# WASTEWATER SYSTEM IMPROVEMENTS
# FOR THE
# GRAND STRAND WATER AND SEWER AUTHORITY

PART 1 TRANSMISSION PIPELINES

PROJECT NO. CA68505.71

ADDENDUM # 2 - Supplement for Rebid

SHEET NO. A-1

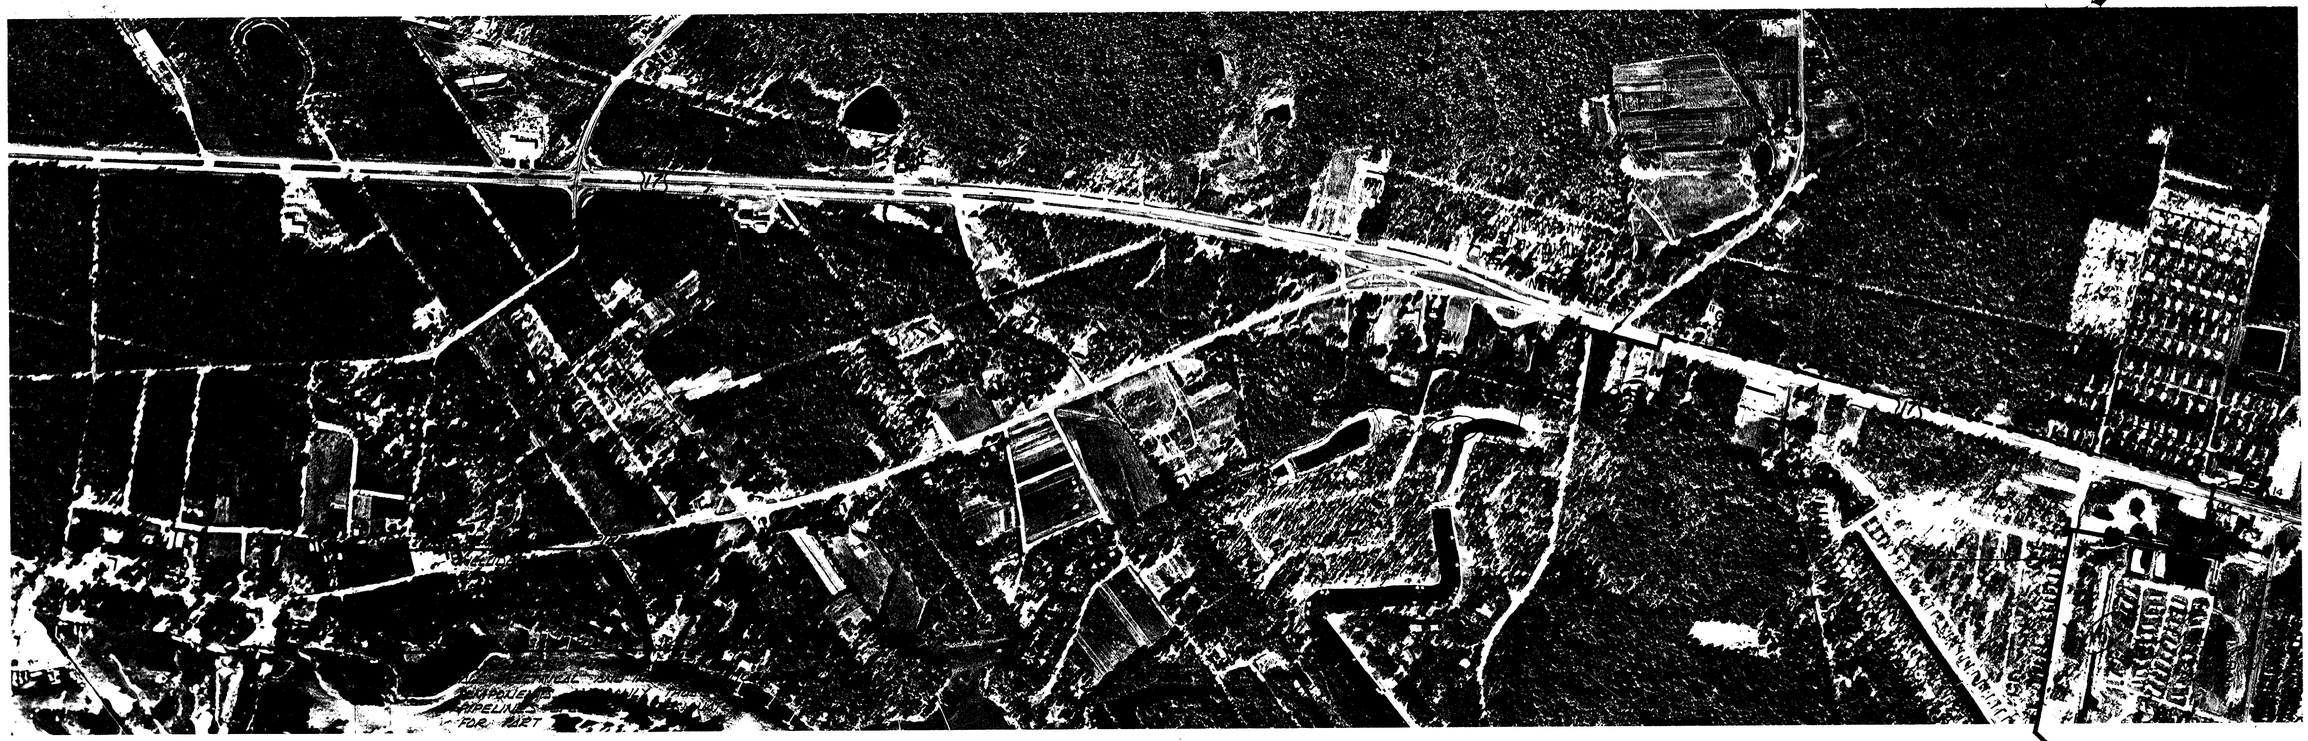
CHANGED 16" F.M. TO 18" DELETED GRAVITY AND ADDED 20" F.M. RELOCATED U.S. HWY 17 CROSSING NEAR M.H. 14 TO M.H. 13. DELETE HWY CROSSING AT MH 17. DELETE REFERENCE TO PART 2 CONTRACTOR FOR 10" F.M. CONNECTION NEAR MH 14.

SHEET NO. A-2

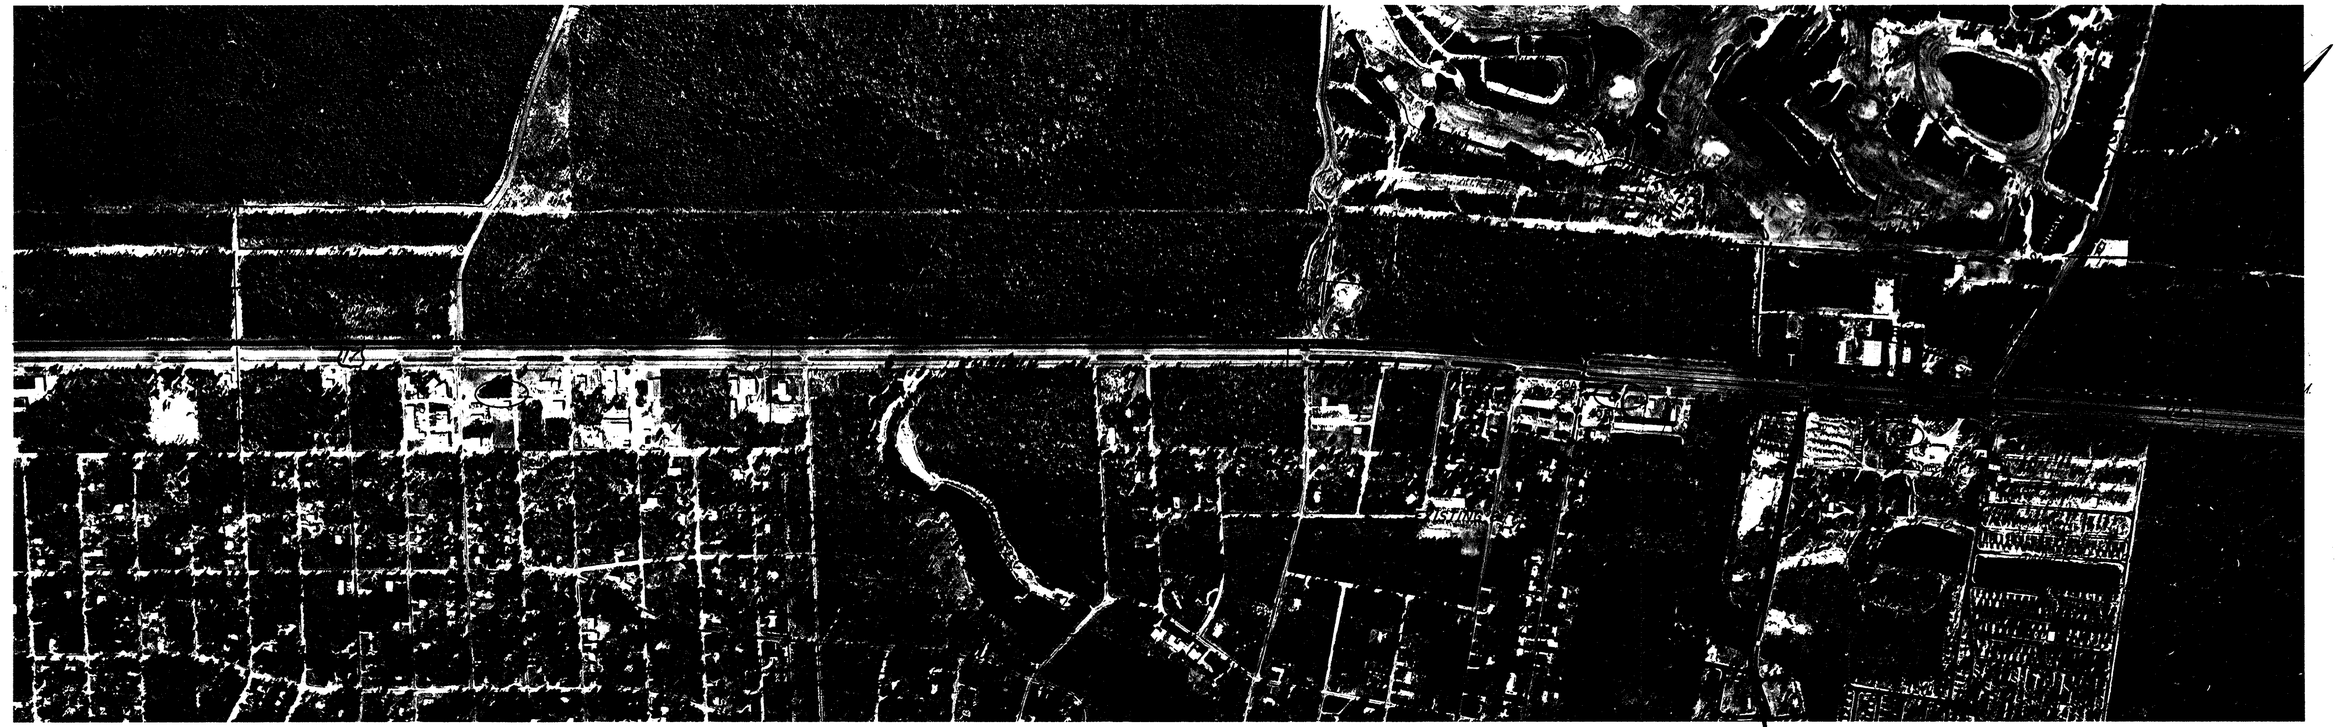
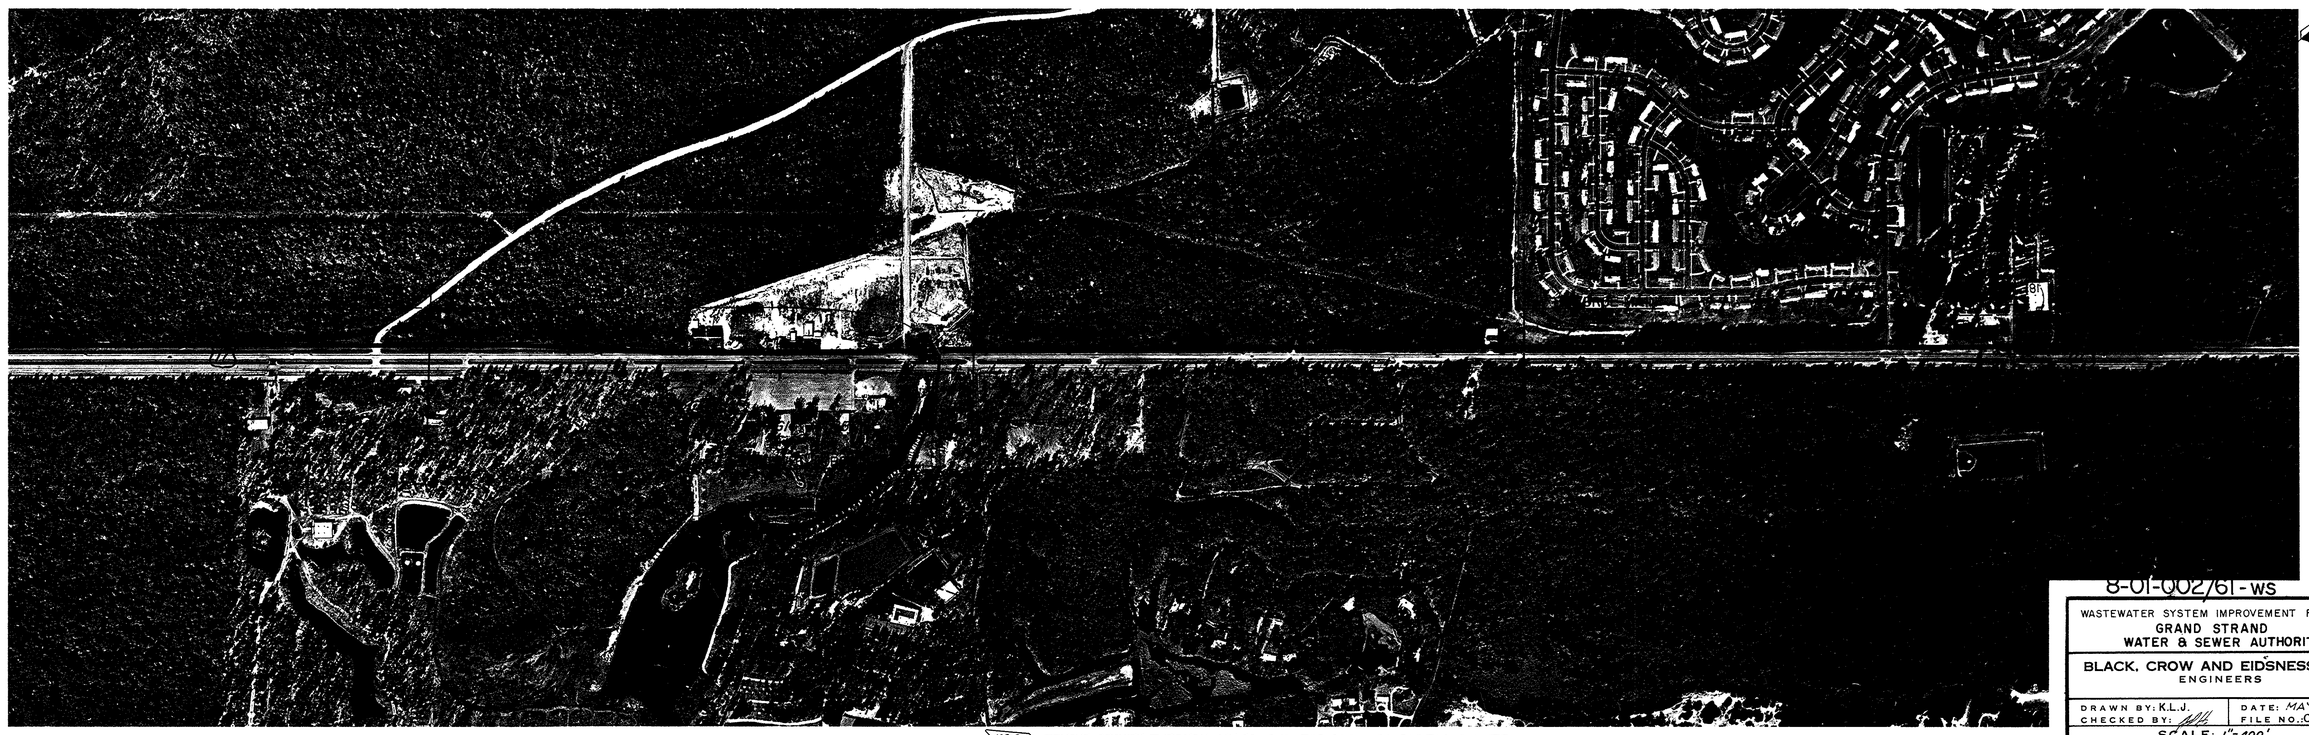
ADD-2 REMOVE GRAVITY THROUGH MH 40 AND REPLACE WITH 20" F.M. DELETE GRAVITY THROUGH M.H. U" 35 AND REPLACE WITH 12" F.M. CHANGE 10" F.M. TO 12" F.M. FROM CONJUNCTION WITH PIRATELAND 6" F.M. TO SOUTH. DELETE CROSSING AT MH U" 31A. DELETE "PART 2" NOTE AT MH 40A, 40B AND 82 AND AT 10" F.M. FROM RS U" 16.

SHEET NO. A-4

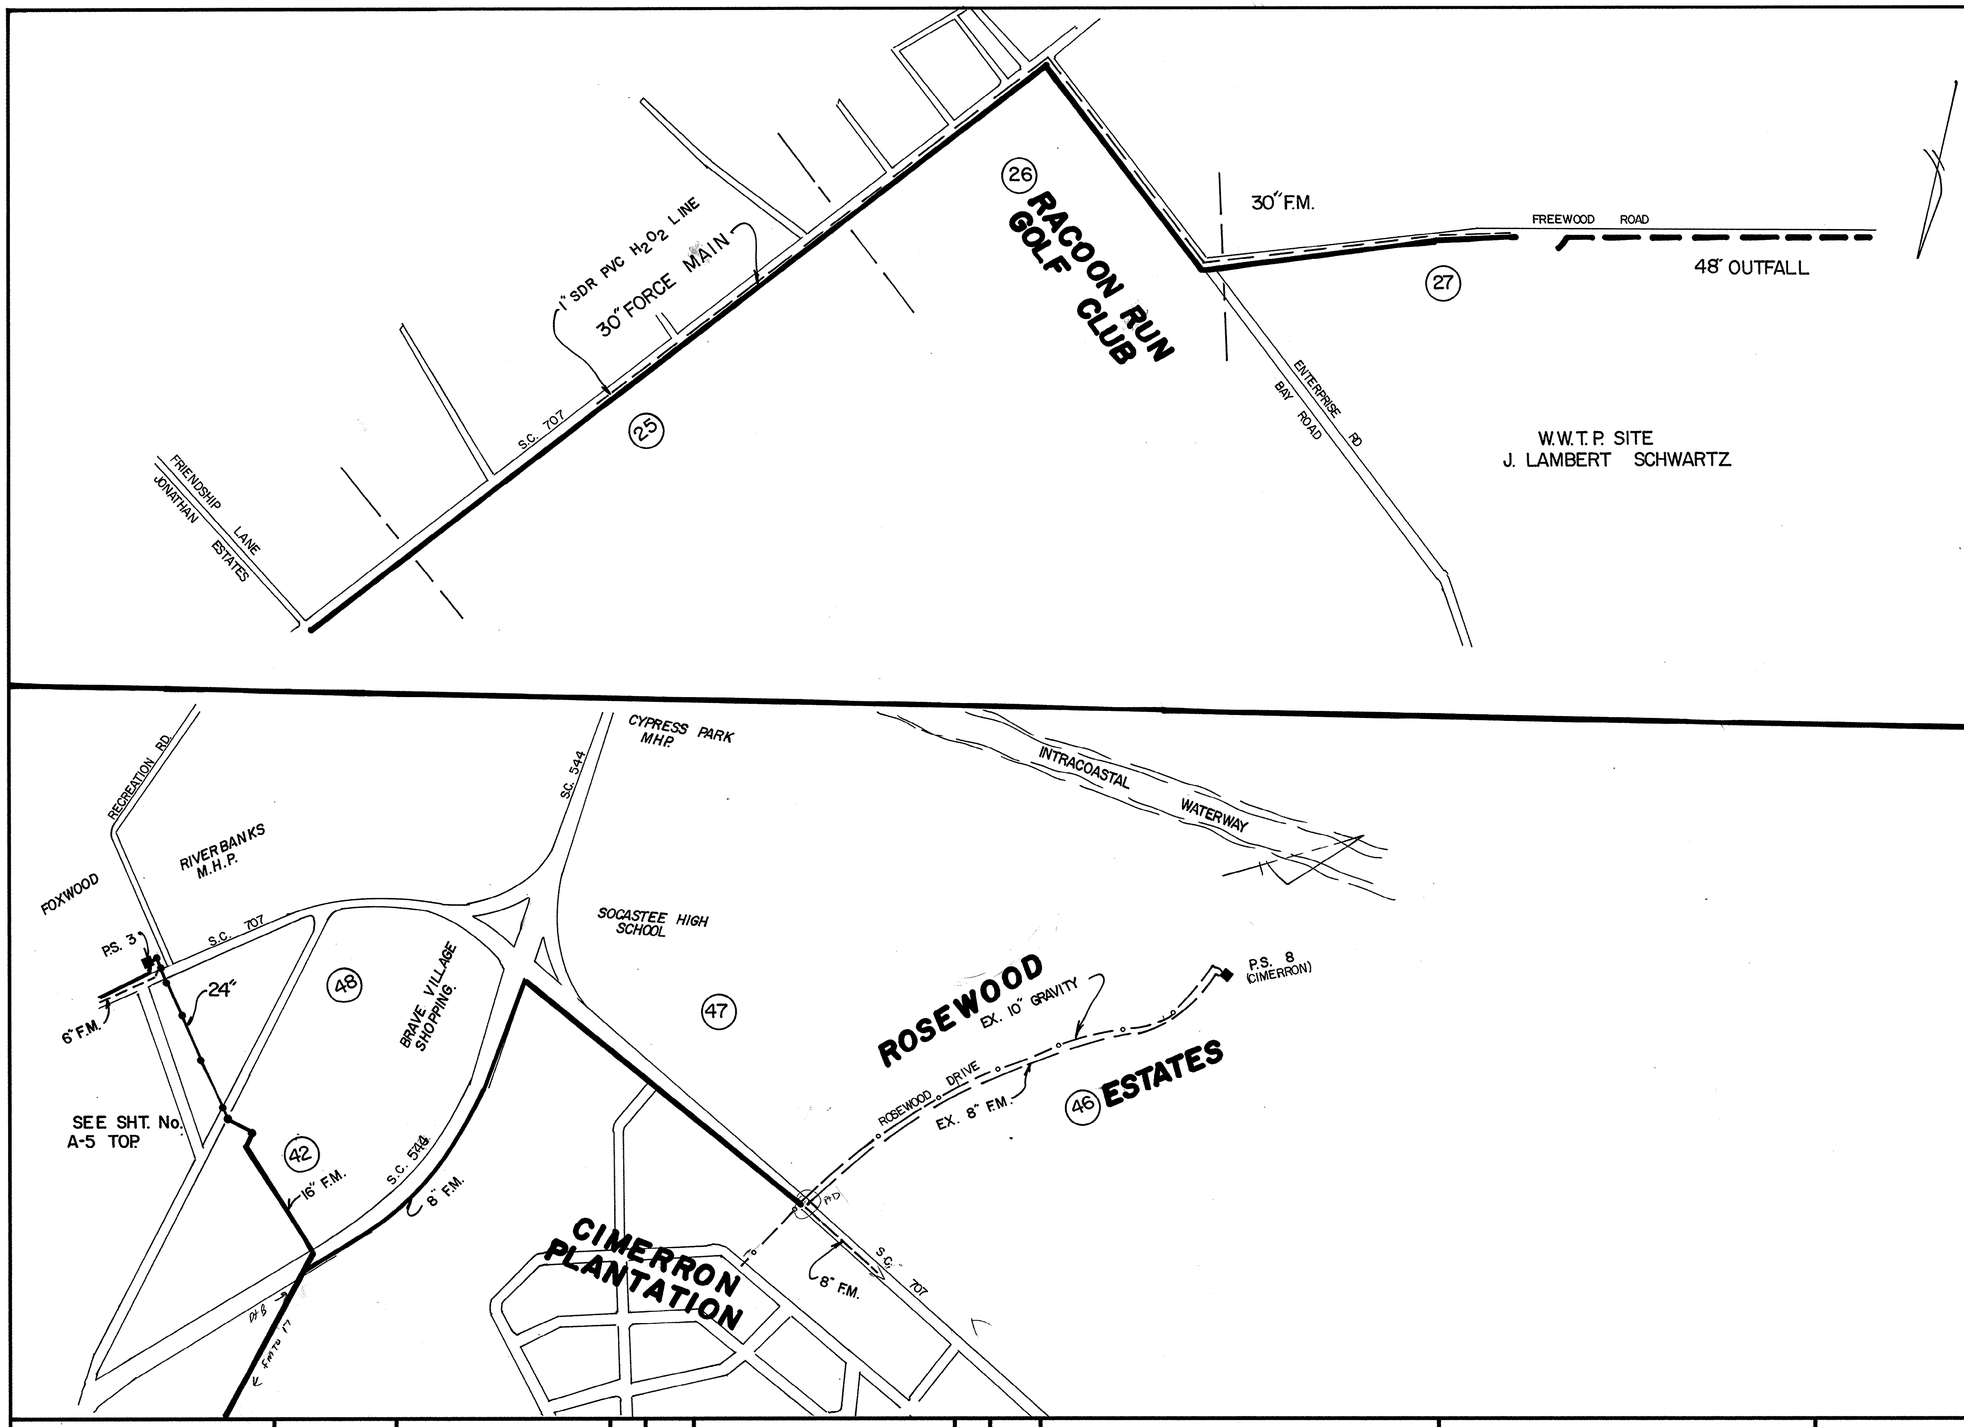
ADD'A. CHANGE 8" F.M. TO PART 1
